**Application for Planning Permission for
Proposed House at Tuen Mun Town Lot No. 550 (TMTL 550), Tuen Mun, N.T.**
(Application No. A/TM/601)

Table 1: S.16 Planning Application No. A/TM/601 - Proposed House at Tuen Mun Town Lot No. 550, Tuen Mun, New Territories.

Response to Comments on Environmental Assessment Report (R8944_2.2)

Figure: 8

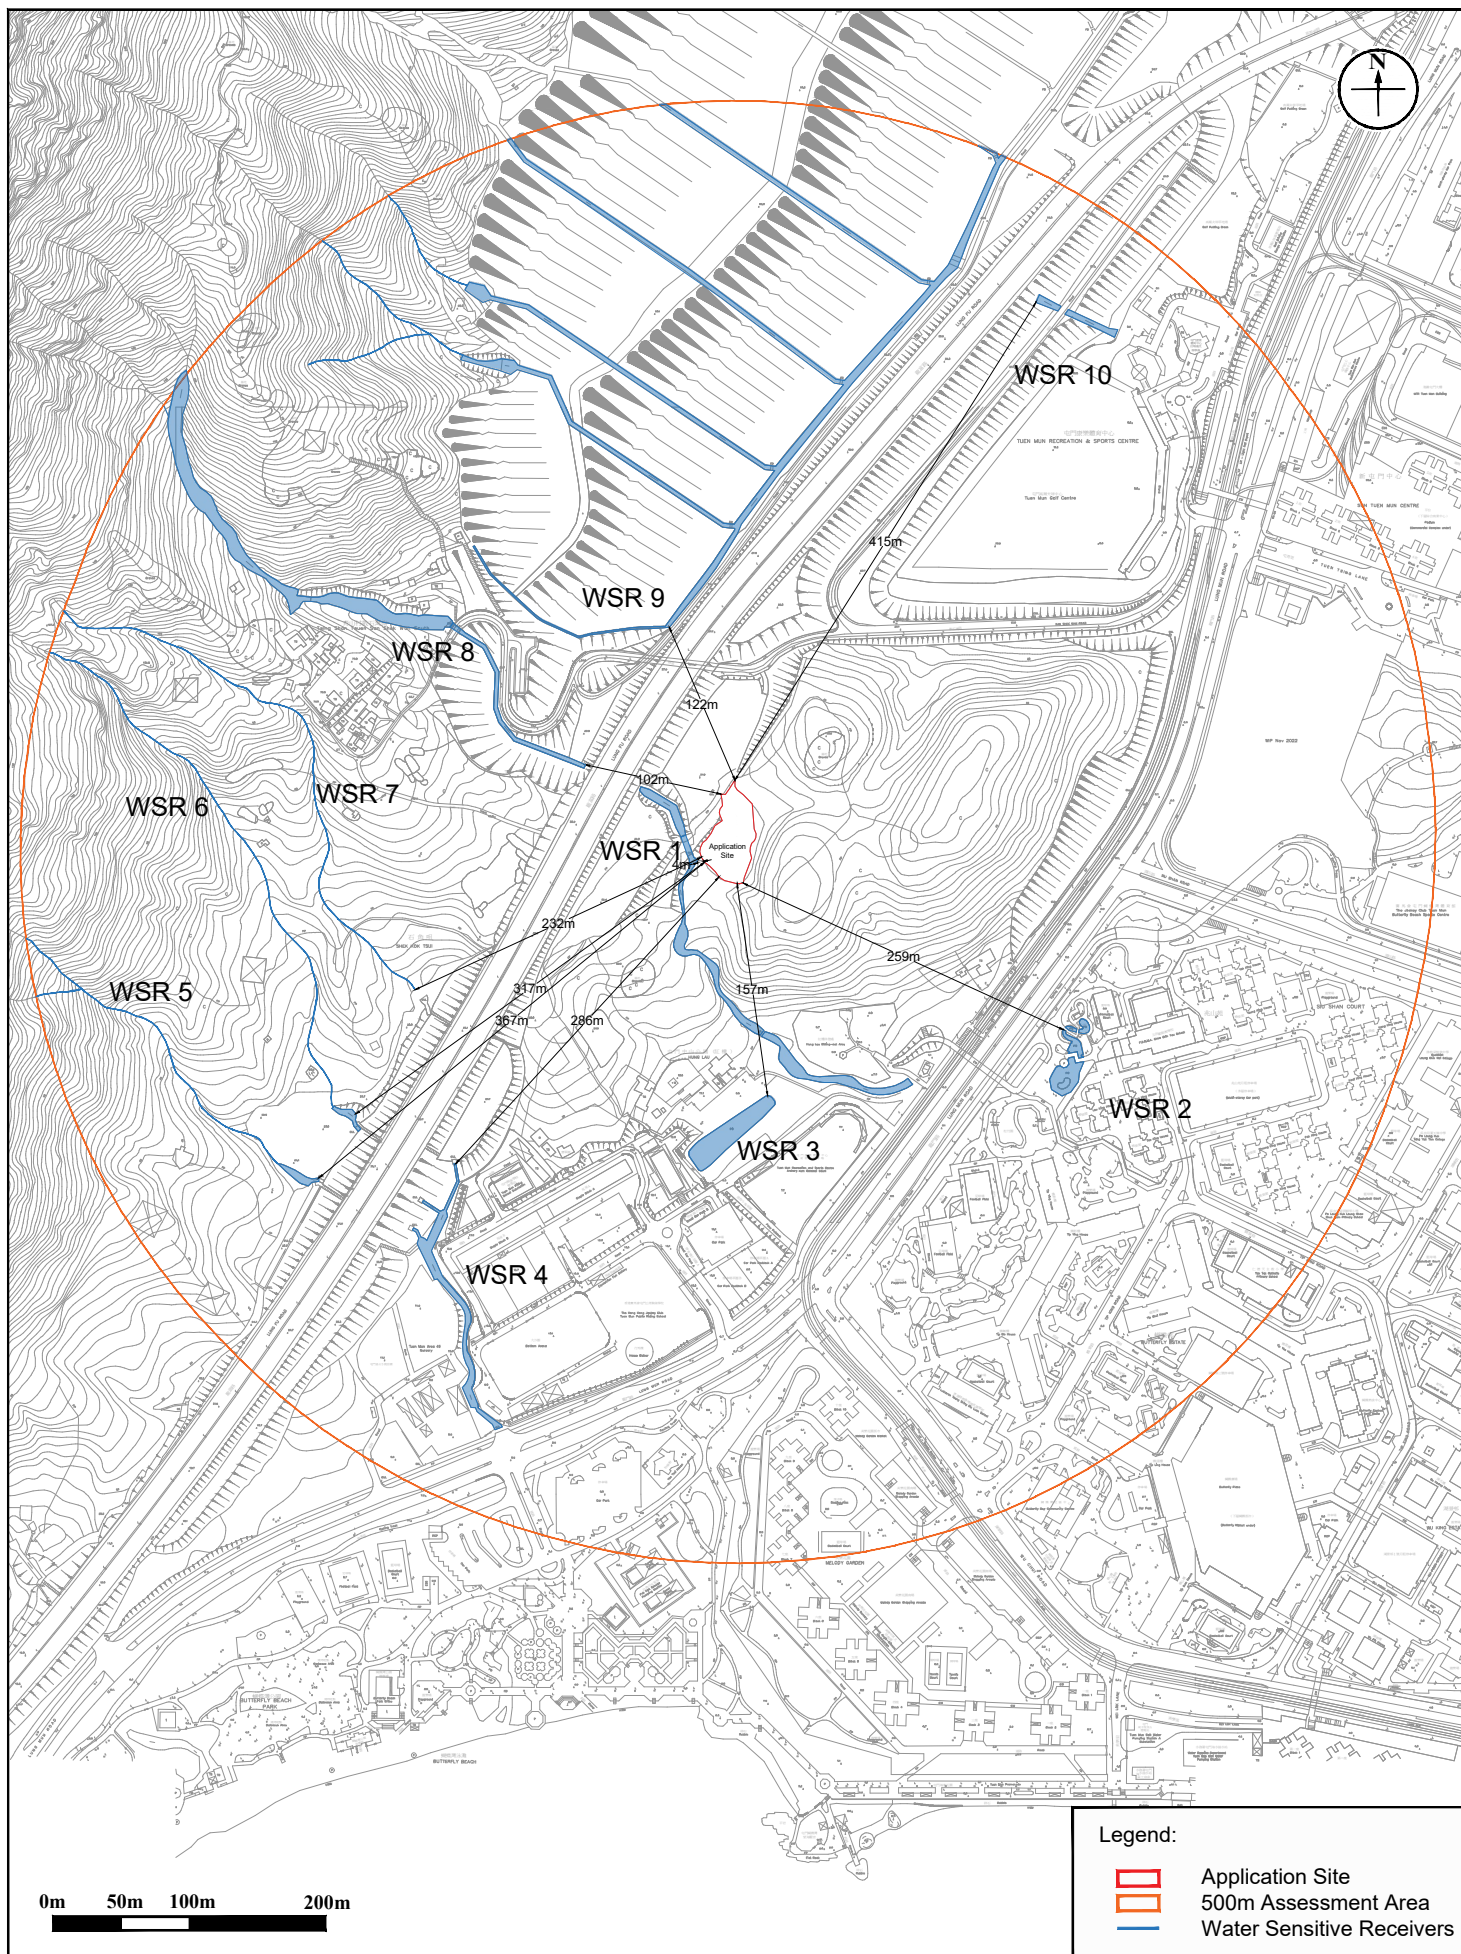
Water Quality		
2.1	S.4.1.1 and Figure 8 – 2.1.1 2.1.1 Please tabulate the WSRs, the table shall include the WSR ID, description, type (natural watercourse, modified watercourse, channelized, pond etc), status (active, abandon) and estimated distance to the site. And, please indicate the WSR in the figure. 2.1.2 For those watercourses in close proximity to the project site, the applicant is recommended to follow standard Recommended Pollution Control Clauses during construction phase and comply with the requirement in ProPECC PN 1/23 during operation. Appropriate additional mitigation measures shall be implemented where necessary.	- Table showing the details of WSR are summarized in Table 4.1, and WSR indication has been provided in Figure 8. - S4.2.2 and S4.3.3 has been updated for those watercourses in close proximity to the project site. S4.2.2 "The Professional Persons Environmental Consultative Committee Practice Note 1/23 Drainage Plans subject to Comment by the Environmental Protection Department (ProPECC PN 1/23) provides guidelines for Drainage Plans of the Proposed Development; whereby domestic sewage should be discharged to a foul water sewer and surface water should be discharged via rainwater pipes to stormwater drains during operation phase."

WSR ID	Description	Type	Status	Estimated Distance (m)
WSR 1	Natural River	Natural Watercourse	Active	4m
WSR 2	Pond	Pond	Active	259m
WSR 3	Pond	Pond	Active	157m
WSR 4	nullah	Channelized watercourse	Active	286m
WSR 5	Natural Meander	Natural Watercourse	Active	367m
WSR 6	Natural Meander	Natural Watercourse	Active	317m
WSR 7	Natural Meander	Natural Watercourse	Active	232m
WSR 8	Natural River	Natural Watercourse	Active	102m
WSR 9	nullah	Channelized watercourse	Active	122m
WSR 10	nullah	Channelized watercourse	Active	415m

Figure: 9

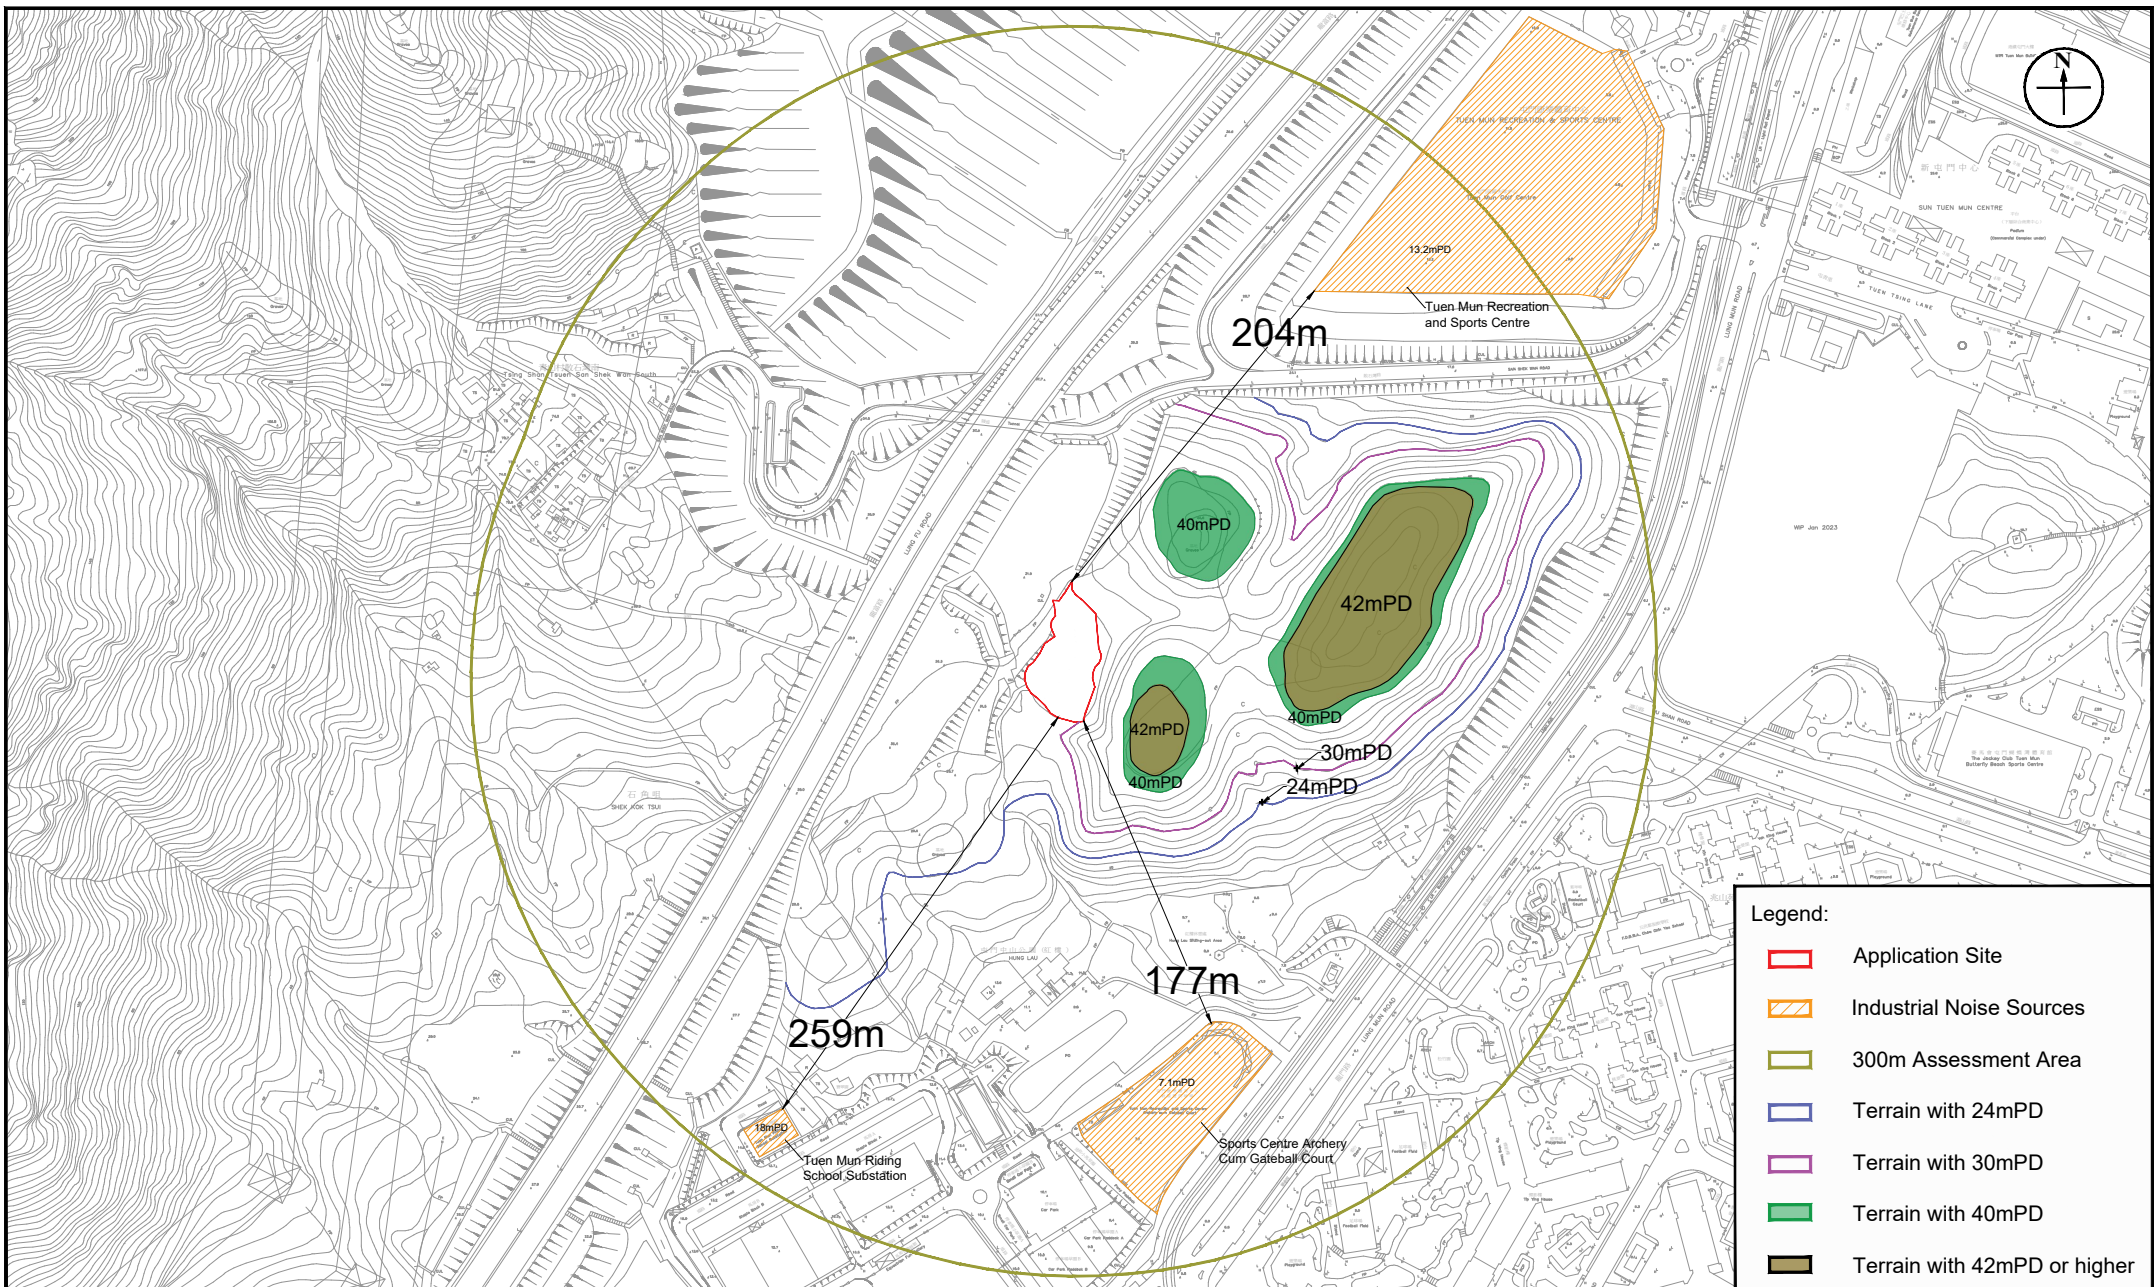
1.2	Figure 9 - Correct the spelling of "Tuen Mun Riading School Substation" to "Tuen Mun Riding School Substation."	Figure 9 has been revised.
1.3	Noted that the TD's endorsement on the RTNIA methodology is provided in the Appendix 2. Please record and make reference at the appropriate section in the main text, e.g. S.3.4.2, that TD has no adverse comment on the subject methodology and their reply record is given in Appendix 2. The traffic consultant should also confirm that TD's endorsed methodology has been strictly adopted in preparing the traffic forecast and so the validity of the traffic data.	Transport Department (TD) has no adverse comment on the methodology for the traffic forecast, and the Project Traffic Consultant confirms that TD's endorsed methodology has been strictly adopted in preparing the traffic forecast. The TD endorsed traffic forecast, TD's endorsement and Project Traffic Consultant's confirmation are shown in Appendix 2.

Figure: 10

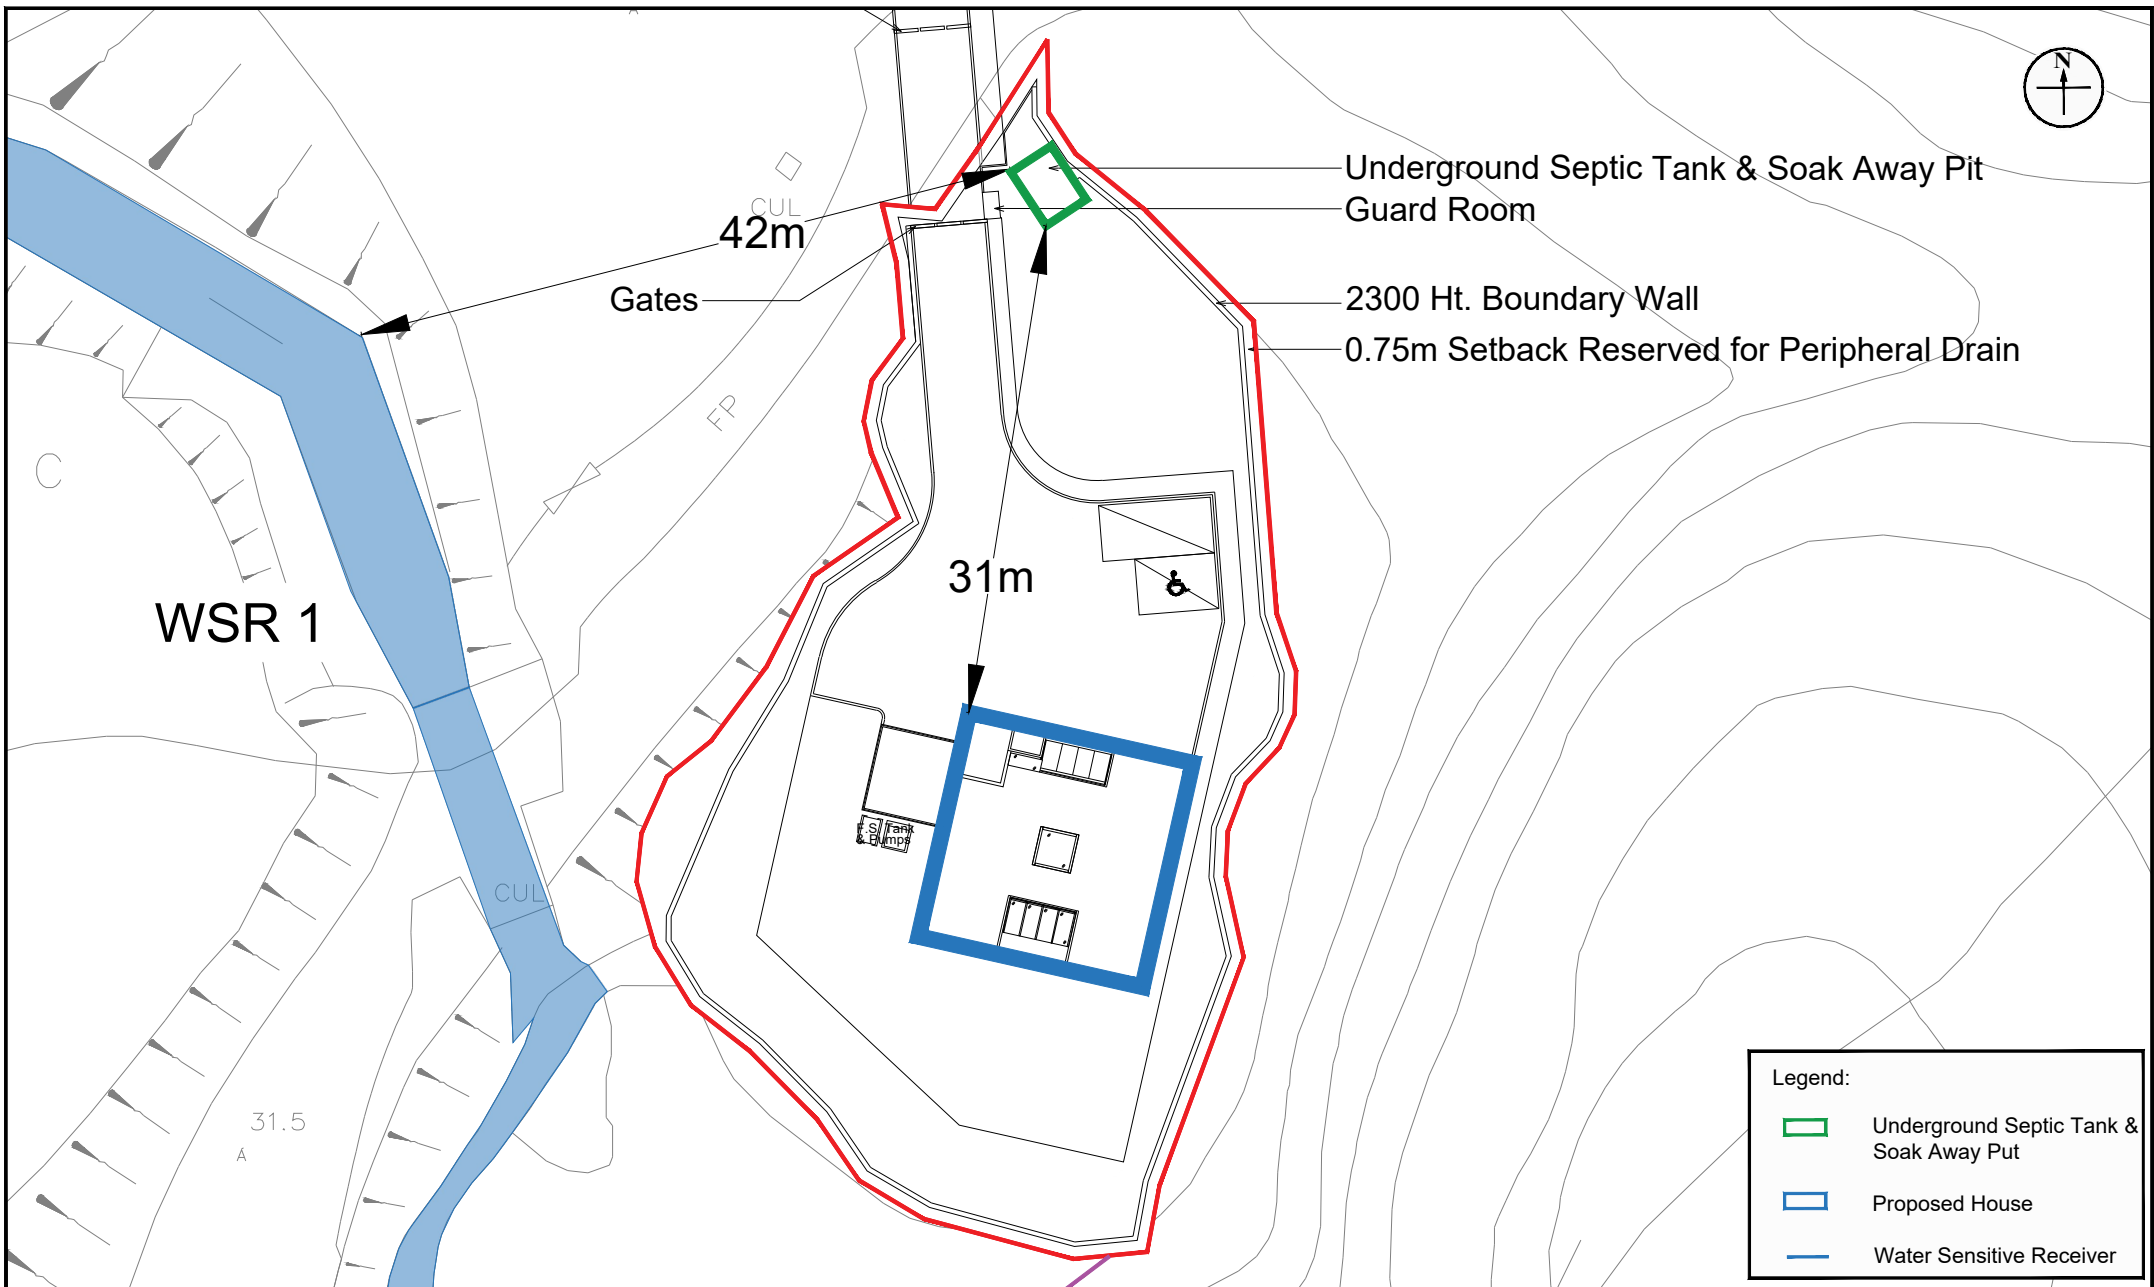
2.3	S.4.7.1 – 2.1.3 Please supplement the estimated ADWF, and refer the location of the septic tank and soakaway pit (ST/S) in the project site with appropriate figure. 2.1.4 The ST/S shall comply with the requirement delineated in the Appendix D of ProPECC PN 1/23 and shall be duly certified by an Authorized Person that the ST/S should be an acceptable means for sewage collection, treatment and disposal.	Further sewerage treatment arrangement will be submitted to Environmental Protection Department for approval at the detailed design stage. In view of that the development and effluent volume are small in scale(1 residential unit with flow rate of 0.7m ³ per day) and with distance of ~31m between the proposed septic tank and proposed house development (as shown in Figure 10), this system is same as that adopted in the previous approved Holiday Camp application (A/TM/469), all the requirement as delineated in Appendix D of ProPECC PN 1/23 would be followed, and septic tank and soakaway pit (ST/S) shall be duly certified by an Authorized Person that the ST/S should be an acceptable means for sewage collection, treatment and disposal.

- 4.7.1 At present, there is no existing or planned public sewer for connections in the vicinity of the Application Site. Given that the development is small in scale. All sewage and wastewater generated from the proposed development would be treated by the proposed underground septic tank and treated effluent would be percolated to surrounding subsoil in the soakaway pit. In view of that the development and effluent volume are small in scale (1 residential unit with flow rate of 0.7m³ per day) and with distance of ~31m between the proposed septic tank and proposed house development (as shown in **Figure 10**), this system is same as that adopted in the previous approved Holiday Camp application (A/TM/469), all the requirement as delineated in Appendix D of ProPECC PN 1/23 would be followed, and septic tank and soakaway pit (ST/S) shall be duly certified by an Authorized Person that the ST/S should be an acceptable means for sewage collection, treatment and disposal. It is expected that the operation of the proposed development would not cause operational phase water quality impact.
